**NEW YORK STATE THRUWAY AUTHORITY
DEPARTMENT OF ENGINEERING**

**AMENDMENT NO. 2
TO**

**CONTRACT TAN 26-14
D215082
PAVEMENT REHABILITATION AND MISCELLANEOUS
WORK ON I-190, NIAGARA THRUWAY
FROM MP N0.7 TO MP N4.2
IN THE BUFFALO DIVISION
OF THE NEW YORK STATE THRUWAY
IN ERIE COUNTY**

**IN THE LETTING OF
FEBRUARY 25, 2026**

TITLE OF PROJECT I-190 HIGHWAY REHABILITATION	CONTRACT NUMBER: TAN 26-14
LOCATION OF PROJECT I-190 NIAGARA THRUWAY MP 900.7 TO MP 904.2	DATE: FEB. 2026
TITLE OF DRAWING WZTC SOUTHBOUND SECTION 3/ PHASE 1/ STAGE 2	DRAWING NUMBER: TCP-68

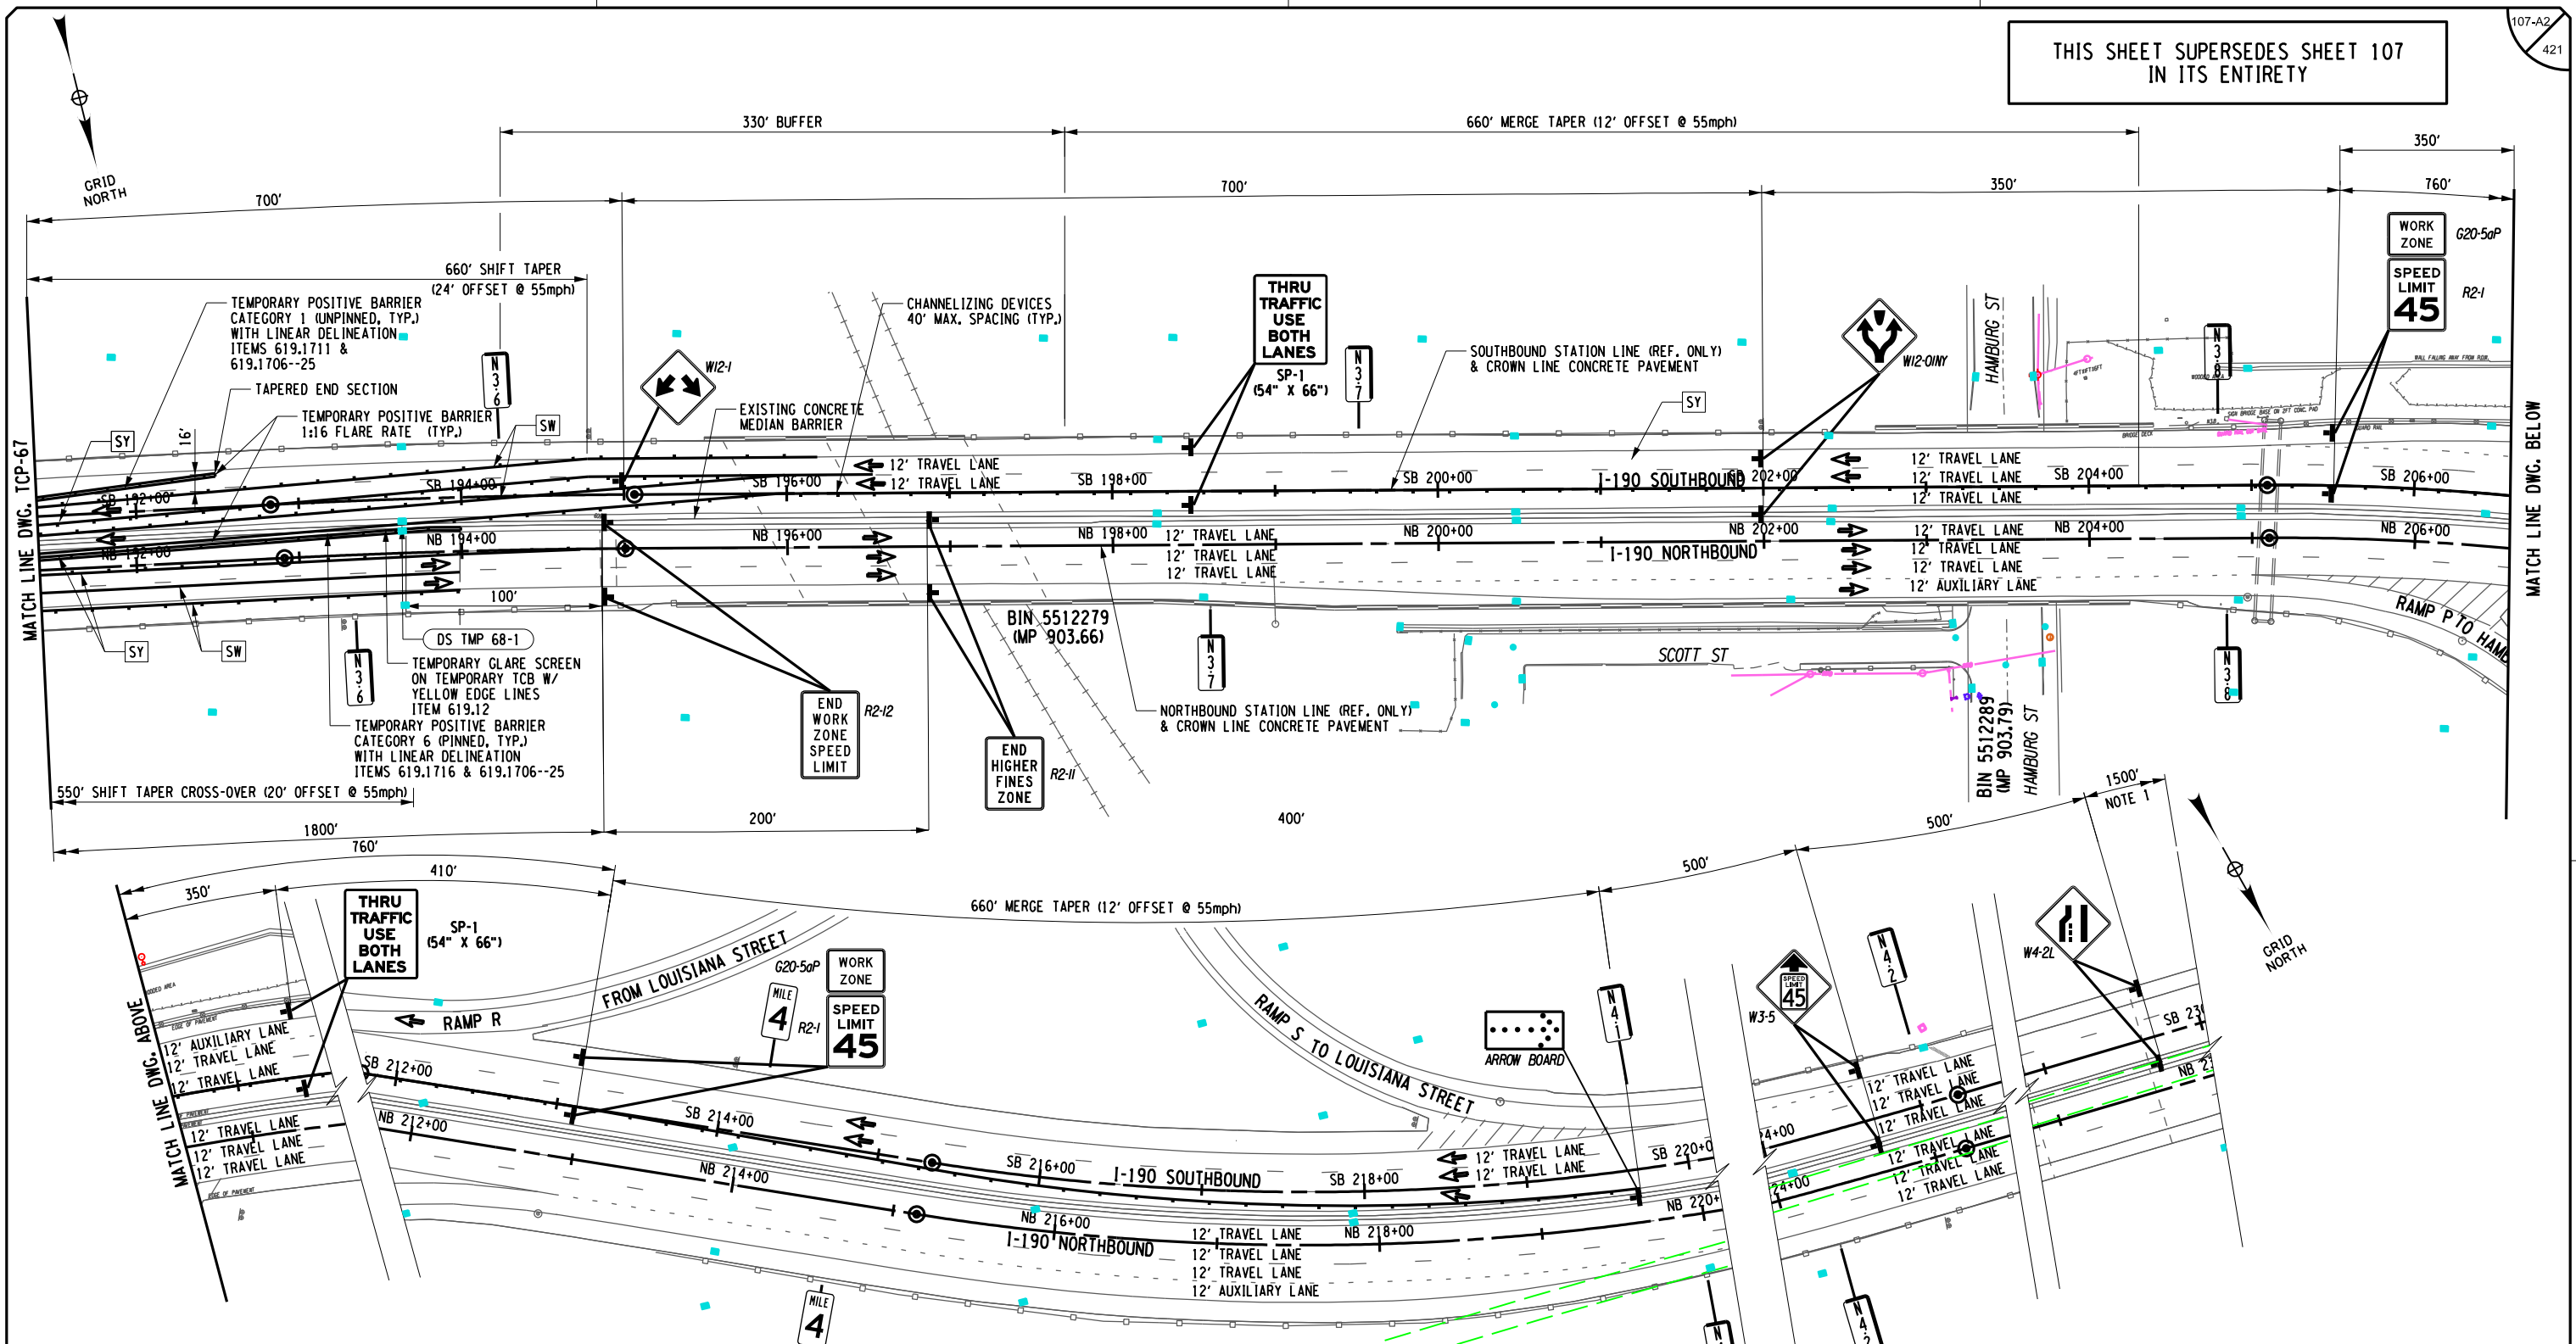
9. **DELETE** Drawing Number TCP-68, Sheet 107 of 421, and **SUBSTITUTE** with the attached Drawing Number TCP-68, Sheet 107-A2 of 421. “SP-1” signs were changed to fit field conditions, and the size of SP-1 sign was added to the sheet.

TITLE OF PROJECT I-190 HIGHWAY REHABILITATION	CONTRACT NUMBER: TAN 26-14
LOCATION OF PROJECT I-190 NIAGARA THRUWAY MP 900.7 TO MP 904.2	DATE: FEB. 2026
TITLE OF DRAWING WZTC NORTHBOUND SECTION 3/ PHASE 2/ STAGE 1	DRAWING NUMBER: TCP-70

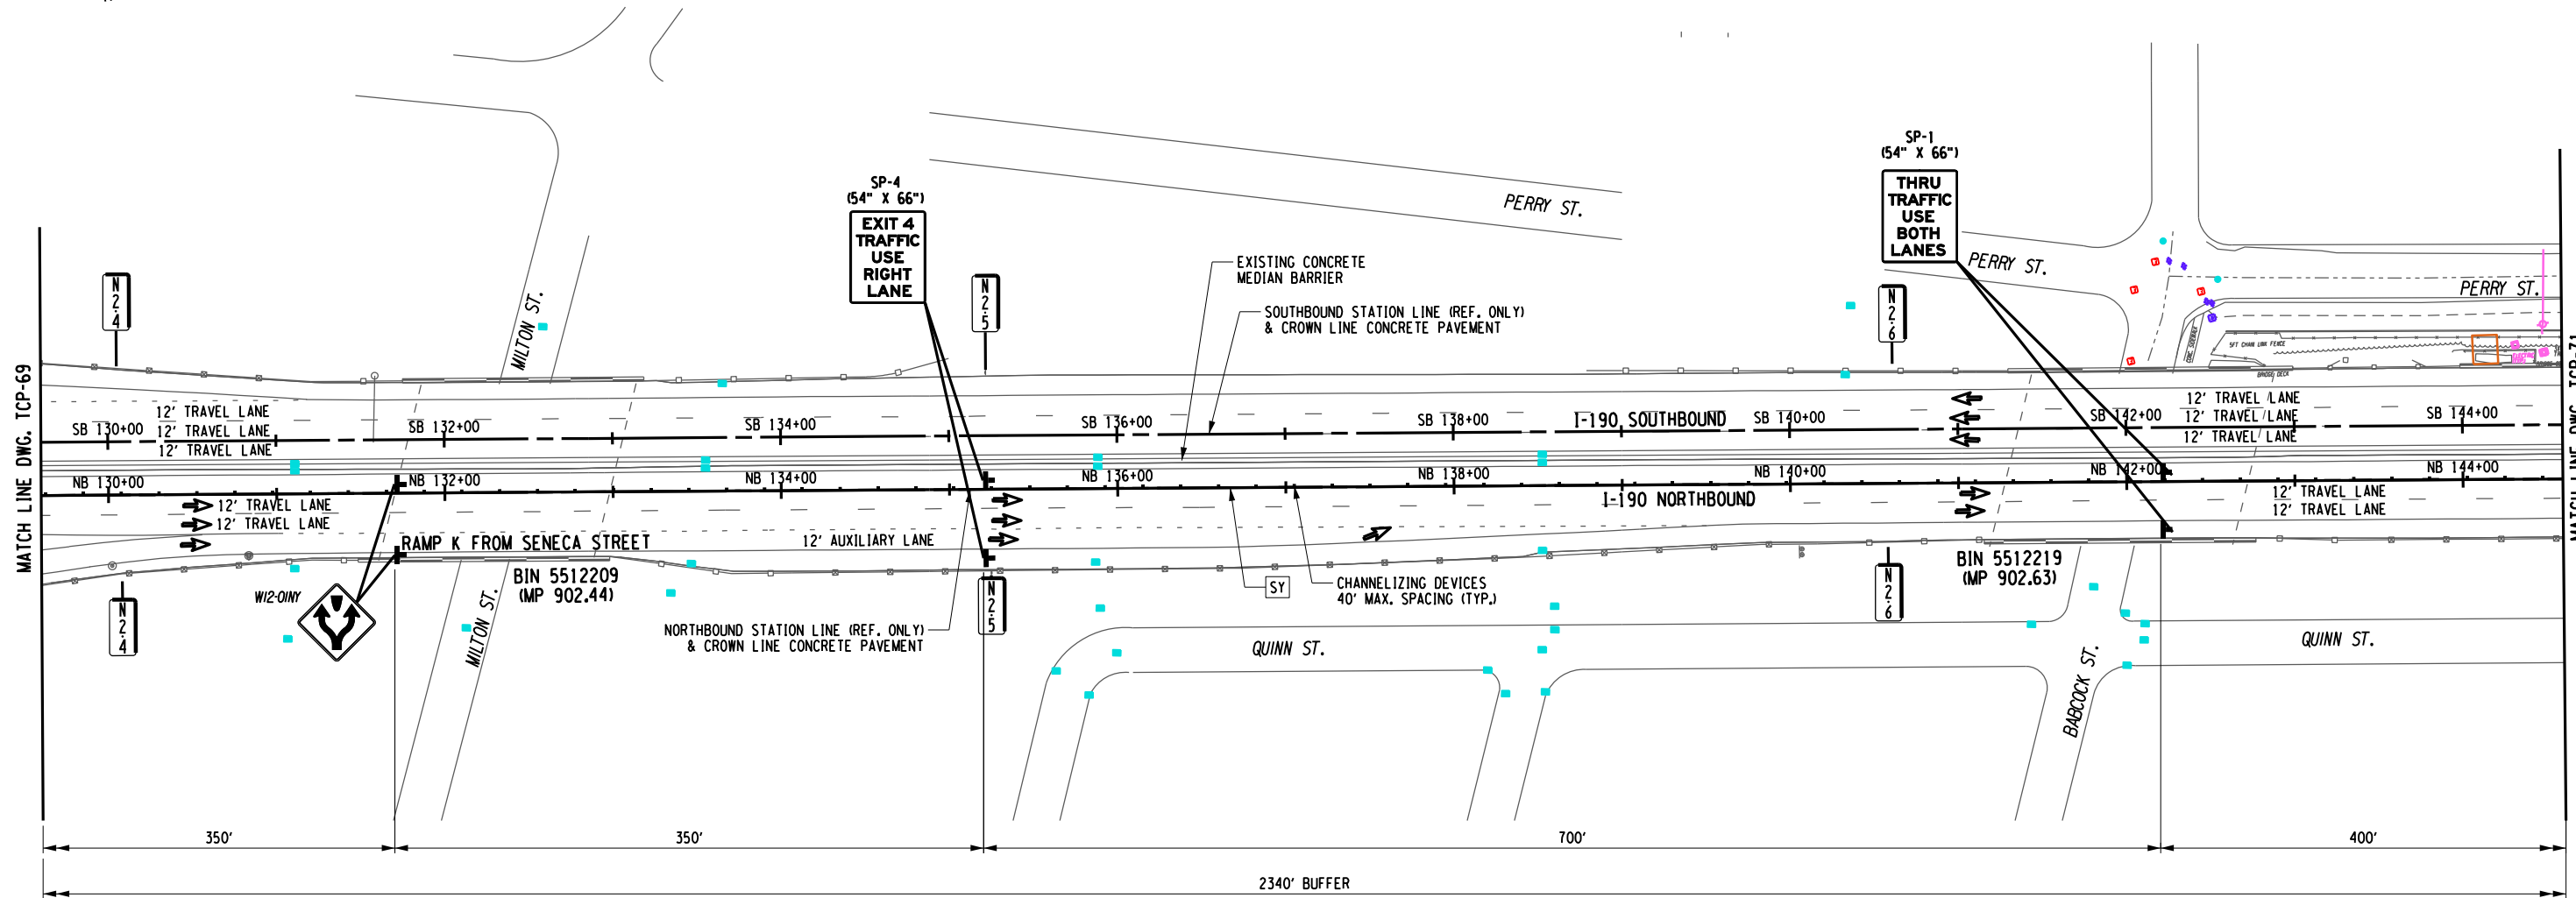
10. **DELETE** Drawing Number TCP-70, Sheet 109 of 421, and **SUBSTITUTE** with the attached Drawing Number TCP-70, Sheet 109-A2 of 421. “SP-1” and “SP-4” signs were changed to fit field conditions, and the sizes of SP-1 and SP-4 signs were added to the sheet.

TITLE OF PROJECT I-190 HIGHWAY REHABILITATION	CONTRACT NUMBER: TAN 26-14
LOCATION OF PROJECT I-190 NIAGARA THRUWAY MP 900.7 TO MP 904.2	DATE: FEB. 2026
TITLE OF DRAWING WZTC NORTHBOUND SECTION 3/ PHASE 2/ STAGE 2	DRAWING NUMBER: TCP-76

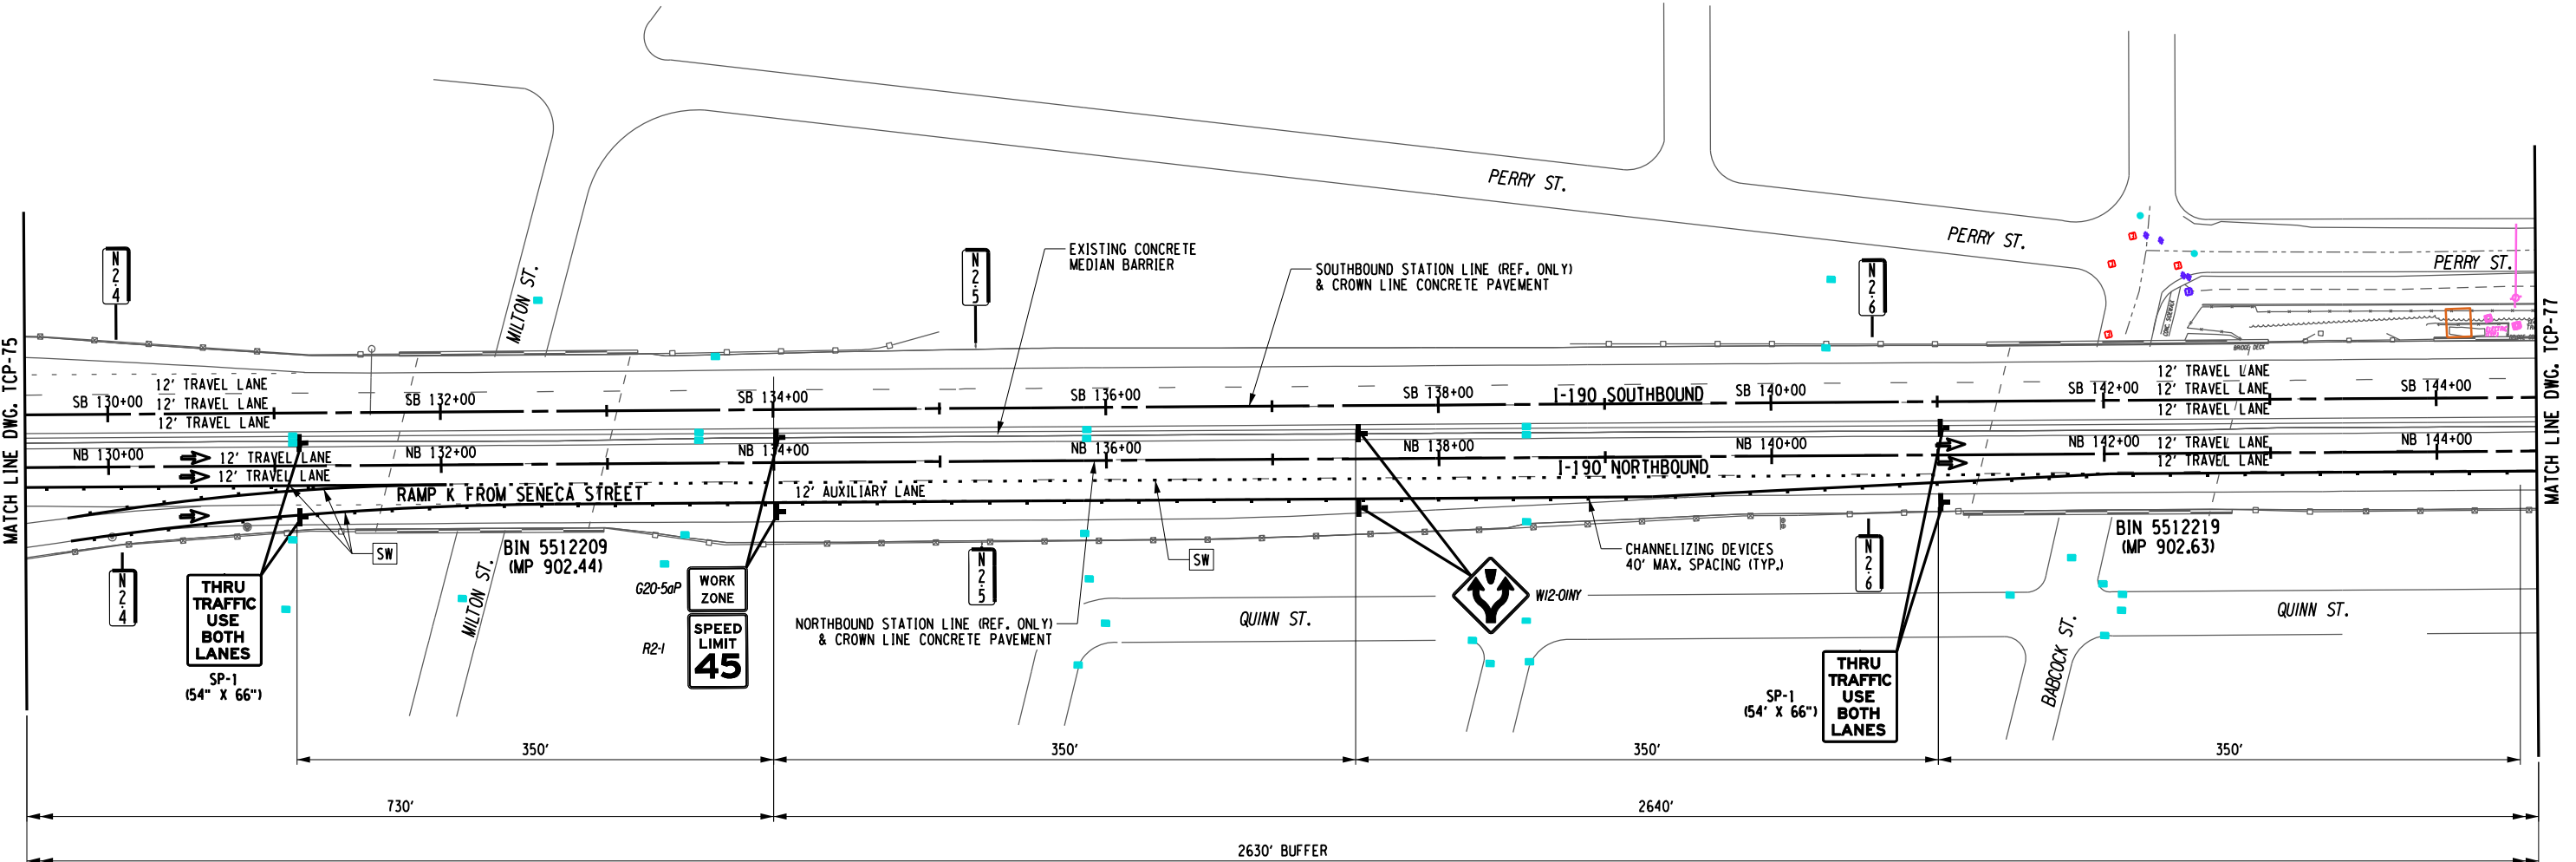
11. **DELETE** Drawing Number TCP-76, Sheet 115 of 421, and **SUBSTITUTE** with the attached Drawing Number TCP-76, Sheet 115-A2 of 421. “SP-1” signs were changed to fit field conditions, and the size of SP-1 sign was added to the sheet.

TITLE OF PROJECT I-190 HIGHWAY REHABILITATION	CONTRACT NUMBER: TAN 26-14
LOCATION OF PROJECT I-190 NIAGARA THRUWAY MP 900.7 TO MP 904.2	DATE: FEB. 2026
TITLE OF DRAWING WZTC SOUTHBOUND SECTION 4/ PHASE 1/ STAGE 1	DRAWING NUMBER: TCP-86

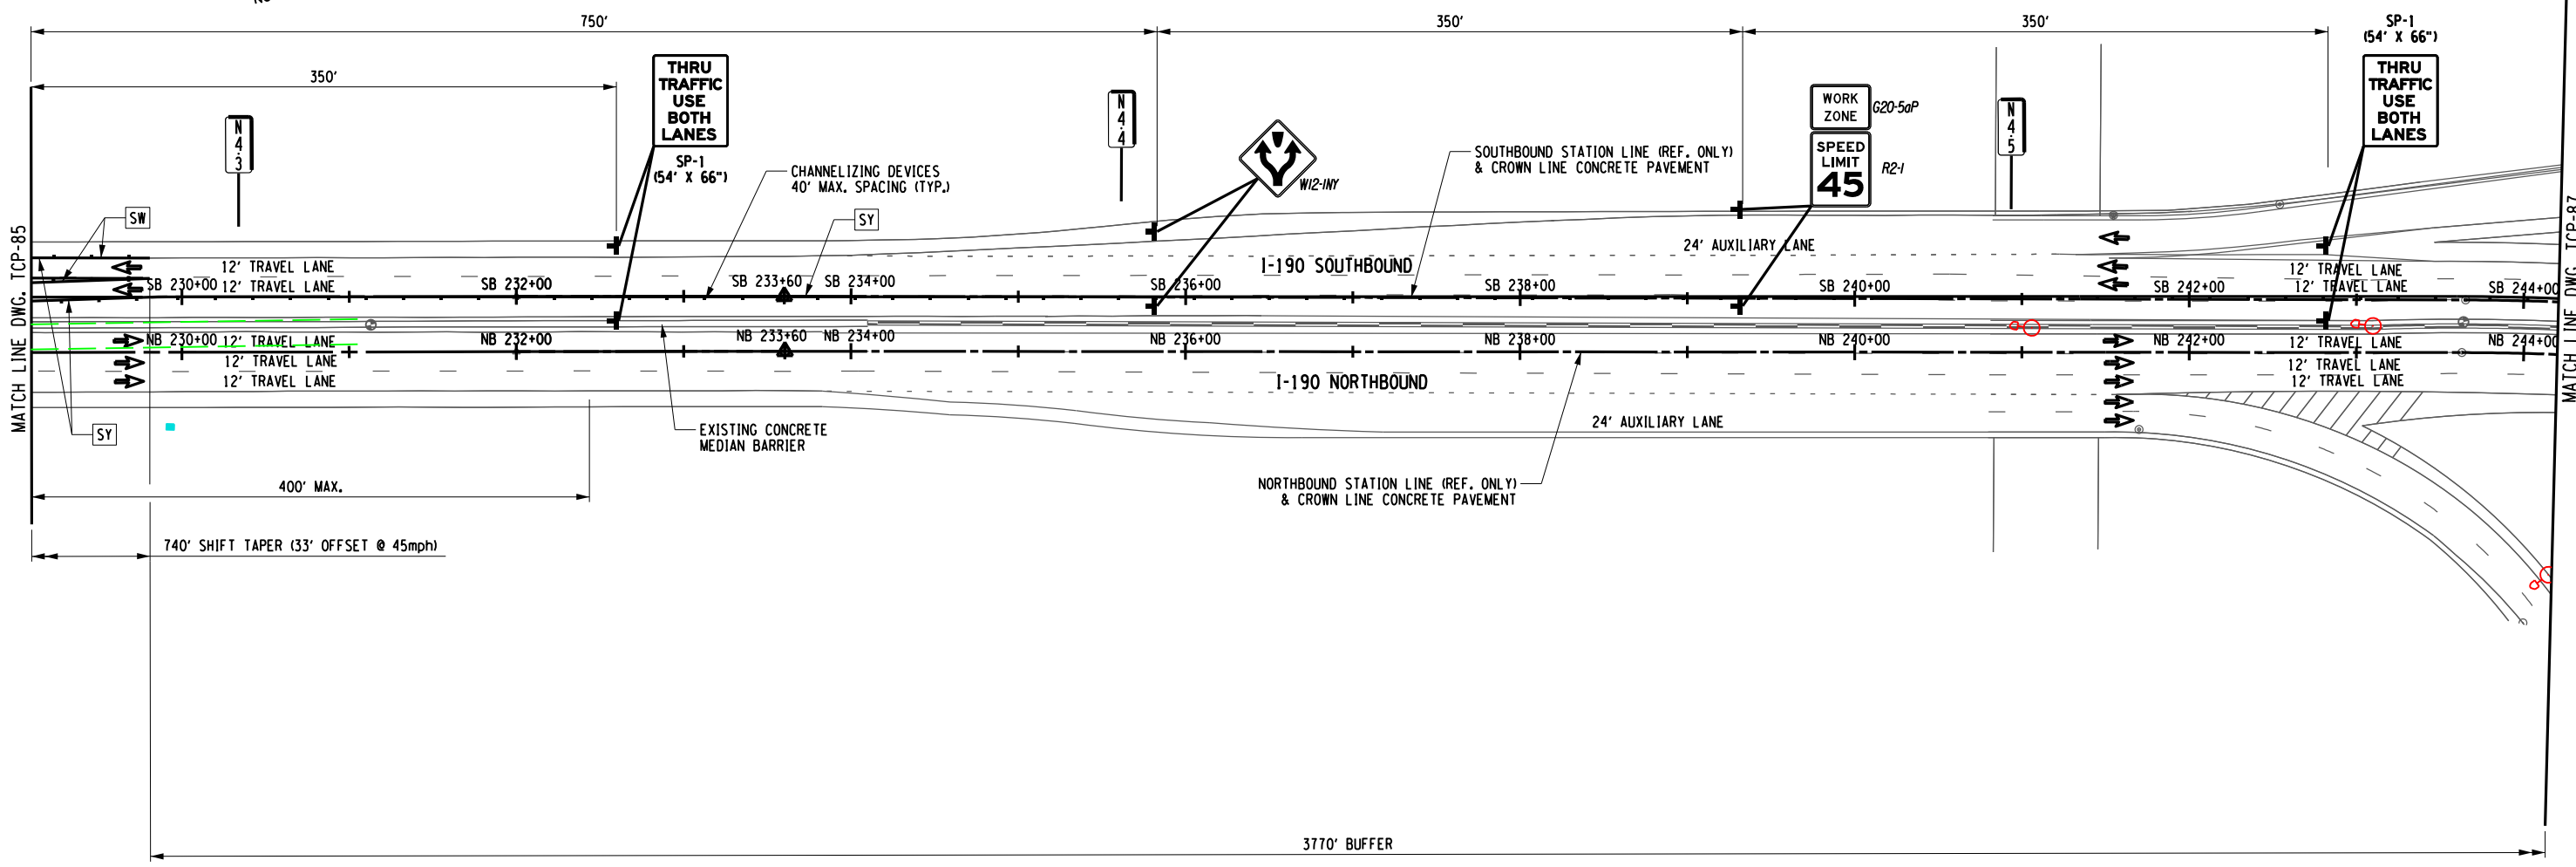
12. **DELETE** Drawing Number TCP-86, Sheet 125 of 421, and **SUBSTITUTE** with the attached Drawing Number TCP-86, Sheet 125-A2 of 421. “SP-1” signs were changed to fit field conditions, and the size of SP-1 sign was added to the sheet.
